# Access Compliance Report

## Public Rights-of-Way

### (Curb Ramps)

Intersection ID: 10033070	Main Street: NORTH_COMMUNITY_HOUSE_RD	Cross Street: N/A	Location: SE
ADA ID: 1E48FE084A0B	Ramp Type: Perp	Initial Pass/Fail: Fail	Overall Compliance: No
Severity Score: 13.75			
Codes/Mitigation Info/Possible Solution		Field Measurements/Component Compliance

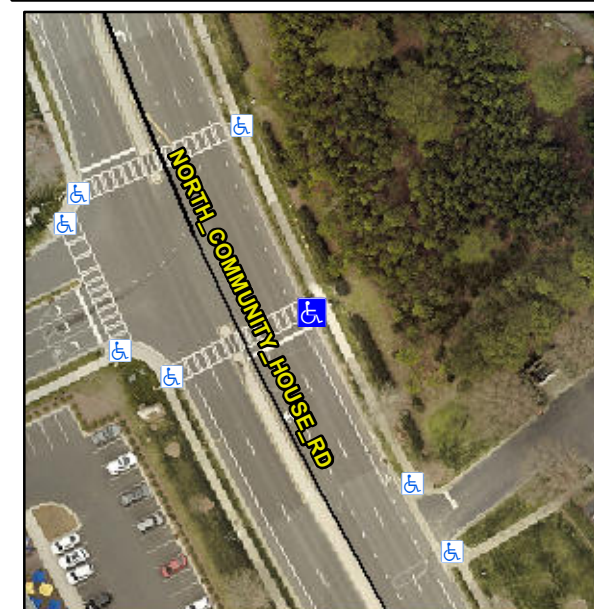
**Not Found, R304.2.2**

Compliance	Description	Data	Compliance	Description	Data
N/A	Ramp Length (in)	49.0	No	Ramp Slope (%)	9.8
Yes	Ramp Width (in)	60.0	Yes	Ramp XSlope (%)	2.9
N/A	Flare Type LT	N/A	N/A	Flare Type RT	N/A
N/A	Flare Slope LT (%)	N/A	N/A	Flare Slope RT (%)	N/A
N/A	Flare Traversable LT?	N/A	N/A	Flare Traversable RT?	N/A
N/A	Landing Length (in)	N/A	N/A	DWS Provided?	N/A
N/A	Landing Width (in)	N/A	N/A	DWS Contrast?	N/A
N/A	Landing Slope (%)	N/A	N/A	DWS Length (in)	N/A
N/A	Landing X Slope (%)	N/A	N/A	DWS Full Width?	N/A
N/A	Landing Curb? (Y/N)	N/A	N/A	DWS Offset (in)	N/A
N/A	Shared Landing?	N/A			
N/A	Gutter Ponding?	N/A	N/A	Gutter Slope (%)	N/A
N/A	Gutter Lip Ht (in)	N/A	N/A	Gutter X Slope (%)	N/A
N/A	Painted X Walk1?	Yes	N/A	Painted X Walk2?	N/A
	X Walk 1 Direction	To SW		X Walk 2 Direction	N/A
N/A	X Walk 1 Width (in)	111.0	N/A	X Walk 2 Width (in)	N/A
	X Walk 1 Slope (%)	4.3		X Walk 2 Slope (%)	N/A
	X Walk 1 X Slope (%)	3.0		X Walk 2 X Slope (%)	N/A

**Remove & Replace Entire Ramp.**
